**RESOURCE MANAGEMENT ACT 1991**  
**NON-NOTIFIED APPLICATION FOR RESOURCE CONSENT**  
**APPLICANT – DC HEARD LTD, 96 PUKUATUA ST, ROTORUA**

That pursuant to Sections 34(4), 94, 104, 105 and 108 of the Resource Management Act 1991, the Rotorua District Council grants consent to the application by DC Heard Ltd to construct a comprehensive residential development of 6 household units at 96 Pukuatua St legally described as Lot 2 DPS 82612.

Unit Development for DC Heard.

**Proposed Town House Development**  
**Pukuatua Street**

## Site Plan

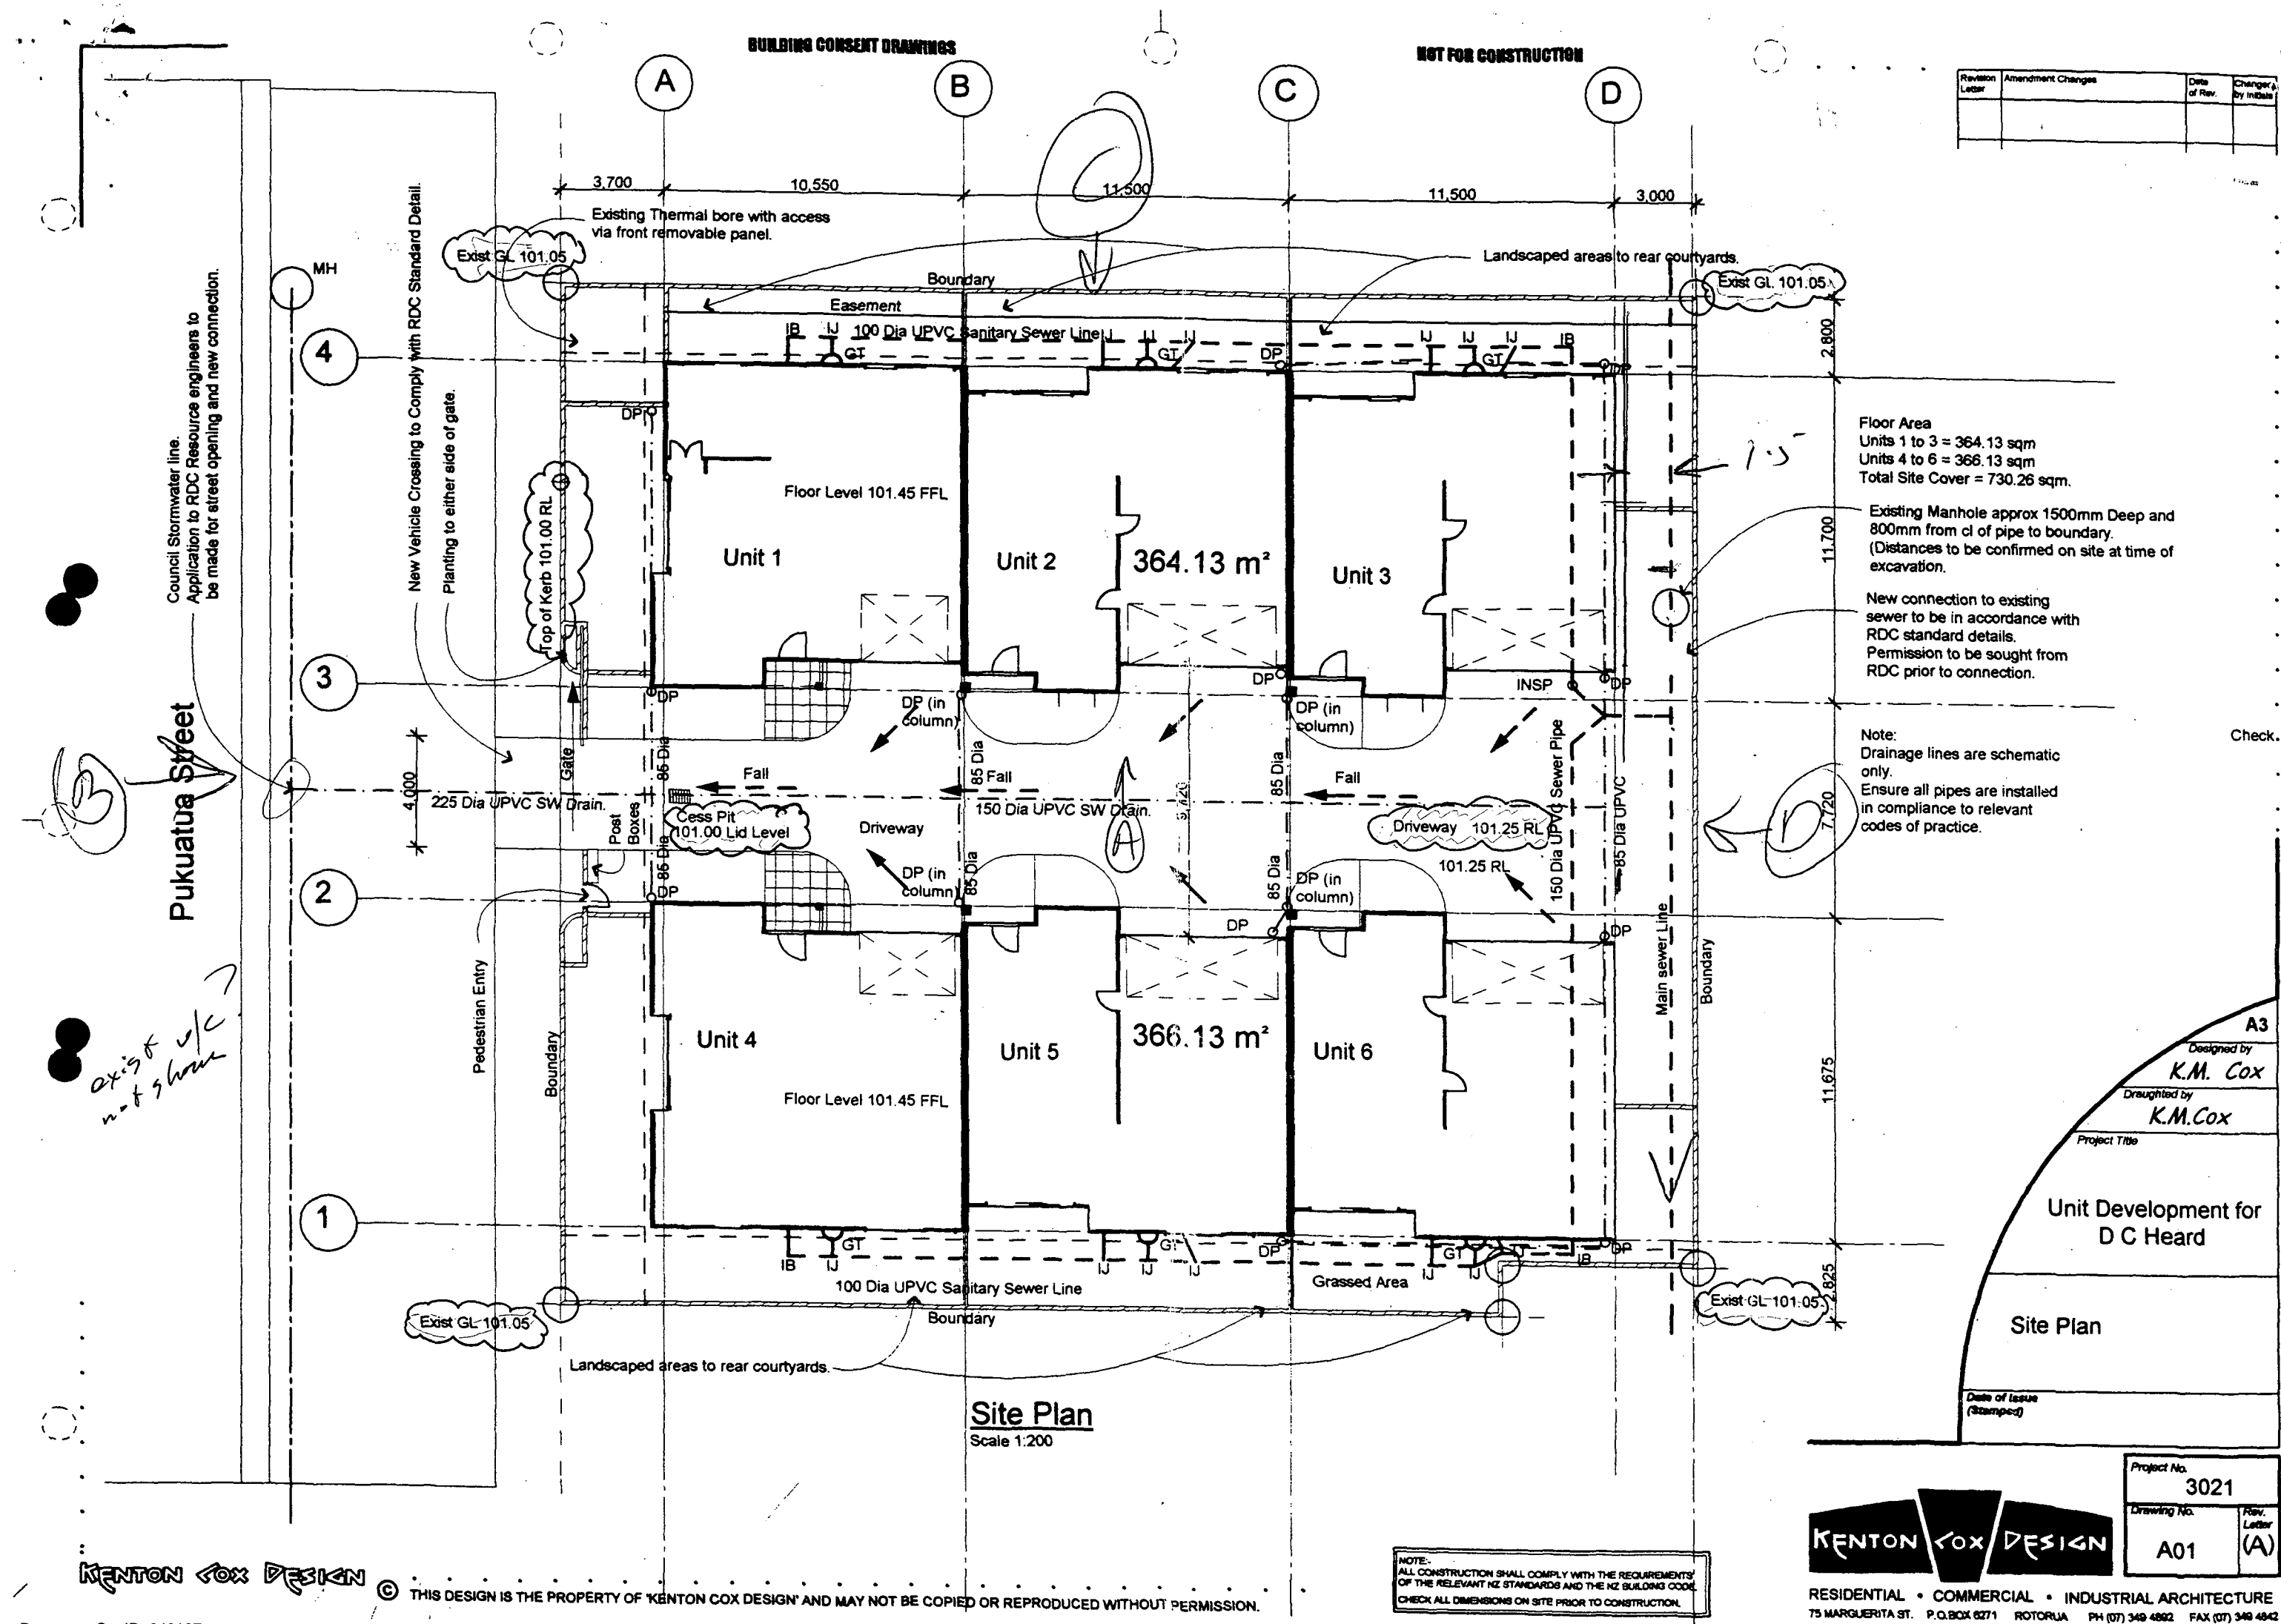
X (2) It is noted that the submitted plans show that a new sewer connection to the public main is proposed. This is **NOT** authorised. The existing connection should be utilised, or alternatively, a new connection provided to the manhole. The applicant is advised to contact Council's Wastewater Operations Technician, Marcus Browne, to discuss this issue.

3. With regard to Condition 6, approval is given for the 4 metre wide vehicle crossing shown on the submitted plans.
